2.4 Hydrologic Engineering

2.4.1 Hydrologic Description

Figure 2.4.2-2. Grading and Site Drainage at the LNP Site

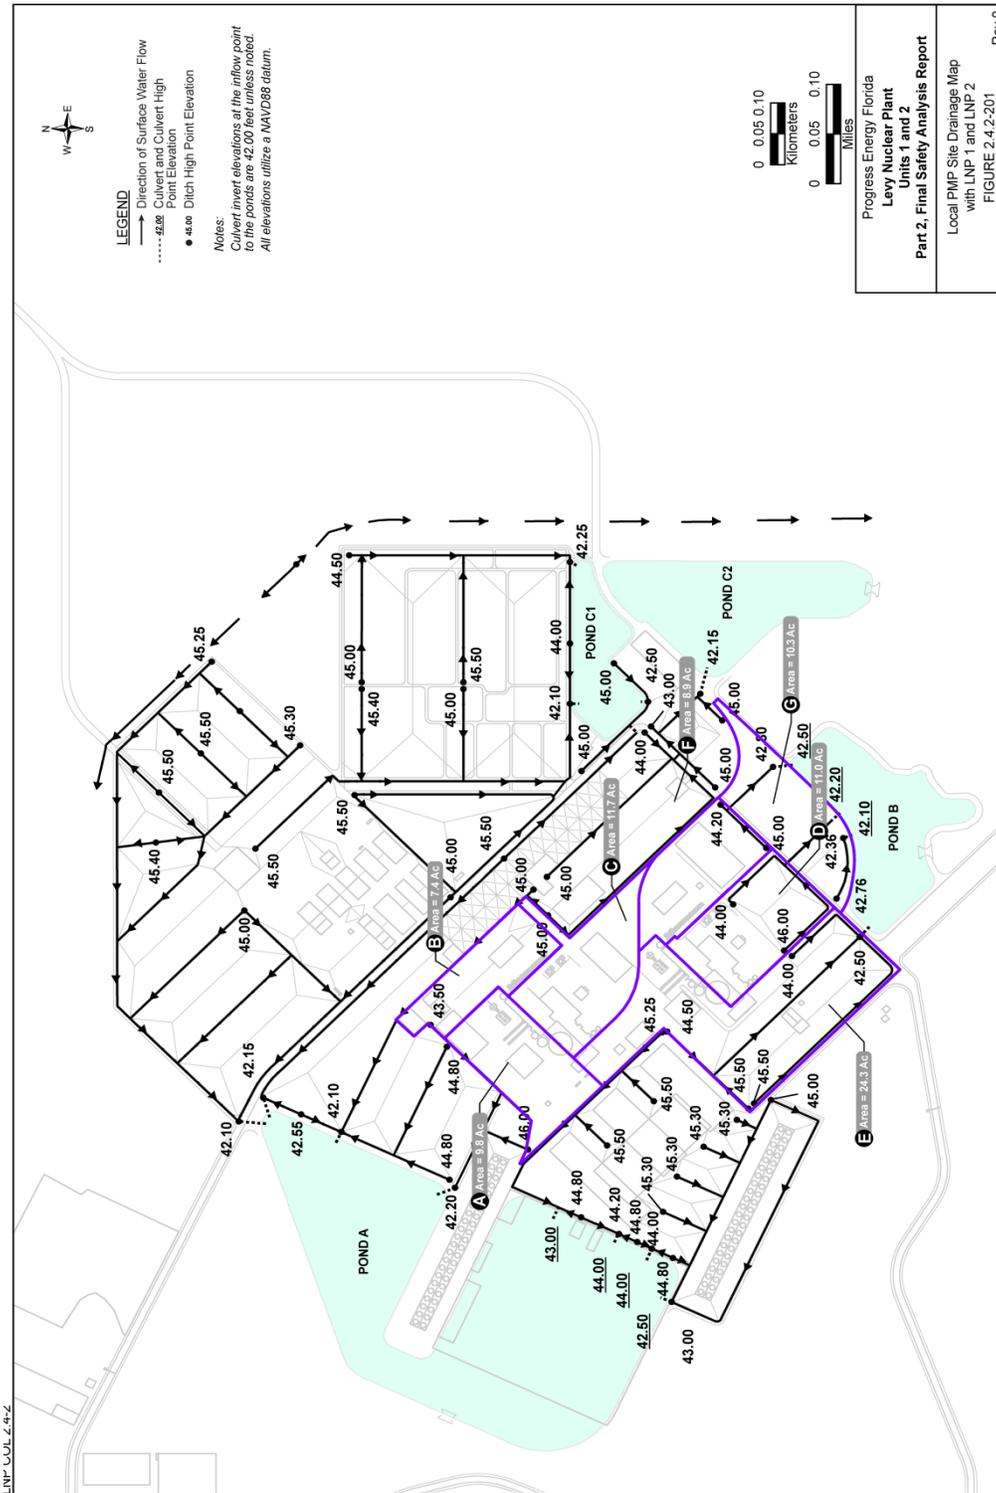
To meet the requirements of GDC 2, 10 CFR 52.17 and 10 CFR Part 100, the applicant should include a determination of the capacity of site drainage facilities. Section 2.4.2.2 of the FSAR states "No dynamic water forces associated with high water levels will occur because of a higher finished plant grade. The dynamic forces associated with the probable maximum precipitation (PMP) are not factors in the analysis or design because the finished grade will be adequately sloped." Please clarify how sloping of the grade excludes consideration of dynamic forces in the analysis and design of safety-related SSCs during the local PMF event or provide an analysis that shows safety-related SSCs would be safe under the static and dynamic effects of the local PMF.

The applicant responded to the staff's RAI 02.04.02-02 in a letter dated July 13, 2009 (ML091950612). The applicant stated that the site grading would be performed such that the floor elevations of SSCs would be above the highest grade elevation. The applicant stated that the plant grade would be sloped away from the SSCs such that runoff would flow away from them. The applicant performed an analysis to estimate the water surface elevation during the local intense precipitation event and reported that the maximum water surface elevation including backwater effects would be less than the nominal plant grade floor elevation of 15.5 m (51 ft) NAVD88.

The staff reviewed the applicant's response and calculations performed to account for the backwater effects during the local intense precipitation event. As stated above, the applicant

Figure 2.4.3-1. Spatial Pattern of PMP Storm over the Withlacoochee River Basin

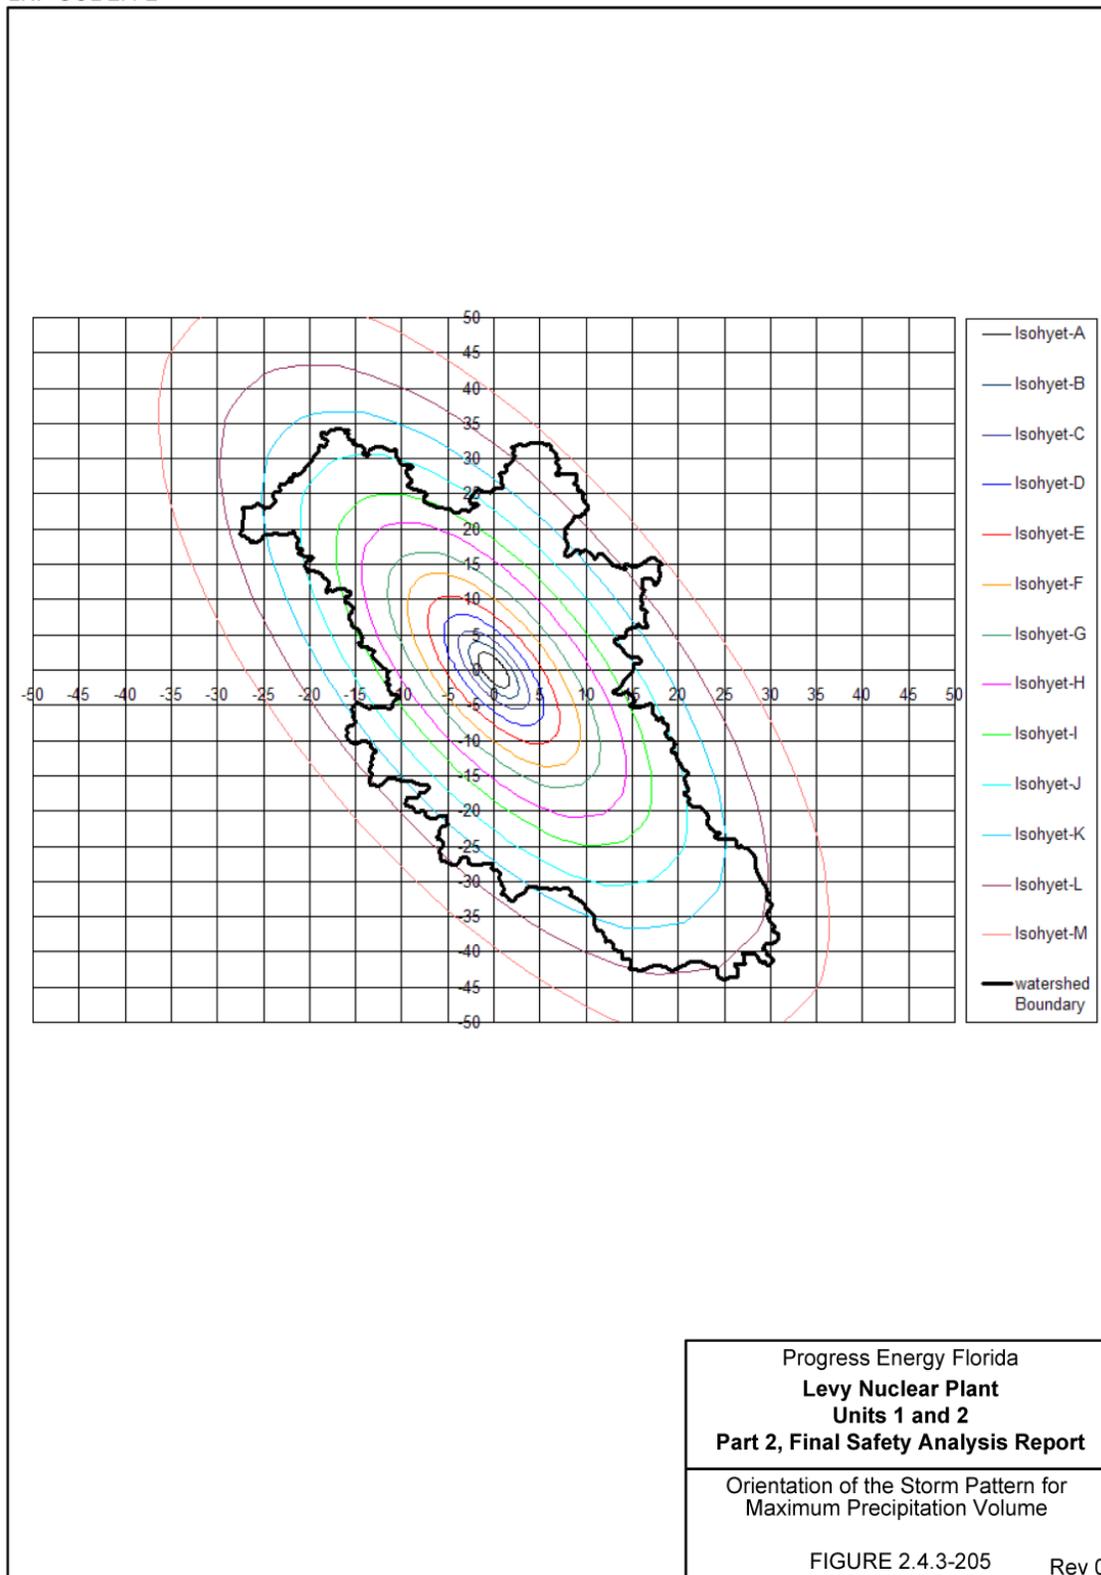
The staff reviewed the applicant's analysis for the estimation of PMP in the Withlacoochee River Basin above Inglis Dam. The staff independently estimated the PMP following the procedures described in HMRs 51 (Schreiner and Riedel 1978) and 52 (Hansen et al. 1982) to verify the applicant's PMP estimates. The staff-estimated PMP depths agree with the applicant's estimates. The staff concluded, therefore, that the applicant has correctly and conservatively estimated the PMP in the Withlacoochee River Basin above Inglis Dam.

Figure 2.4.4-1. The Cross Sections Used in the HEC-RAS Simulation by the Applicant

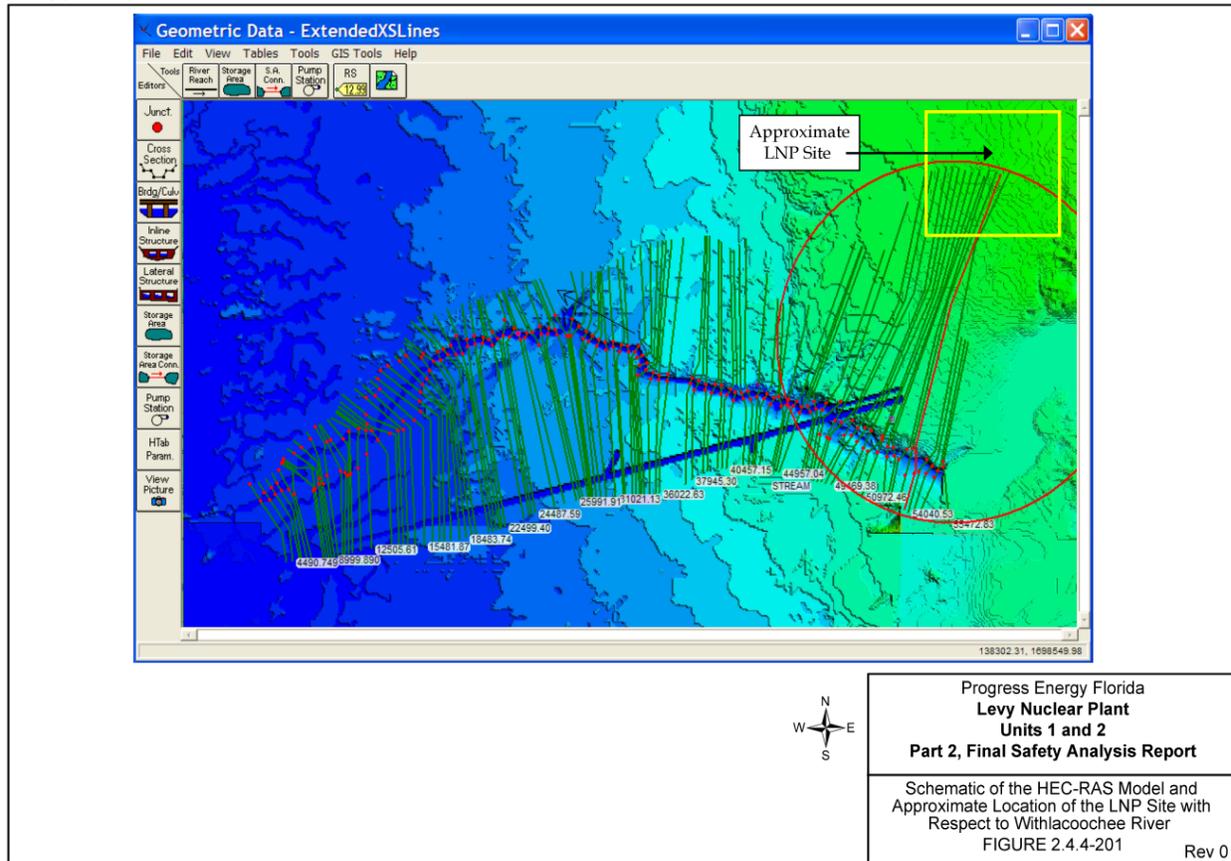
The staff reviewed the methodology adopted by the applicant in its estimation of design basis floodwater surface elevations. To verify the conservativeness of the applicant's approach, the staff issued **RAI 02.04.04-03**, which states the following:

To meet the requirements of GDC 2, 10 CFR 52.17, 10 CFR Part 100, and 10 CFR 100.23(d), an appropriate configuration of the cascade of dam failures and its potential to produce the largest flood adjacent to the plant site is needed. Flood waves produced by postulated dam failure scenarios should be routed to the proposed plant site to conservatively estimate the most severe floodwater surface elevation that may affect SSCs important to safety. Please clarify the steady flow methodology for analysis of the dam break-induced flood and to justify why the estimated flood water surface elevations are conservative.

The applicant responded to the staff's RAI 02.04.04-03 in a letter dated June 15, 2009 (ML091680038). The applicant stated that its steady-state analysis of the postulated Inglis Dam and Inglis Lock failure used a downstream water surface elevation specified by a 10 percent exceedance tide. The applicant stated that flood discharge and water surface elevations estimated by a steady-state approach are overestimated for a flow event that is transient. The staff's confirmatory analyses agree with the applicant's explanation. Therefore, the staff concludes that the steady-state simulation used by the applicant would result in a conservative estimate of the floodwater surface elevation.
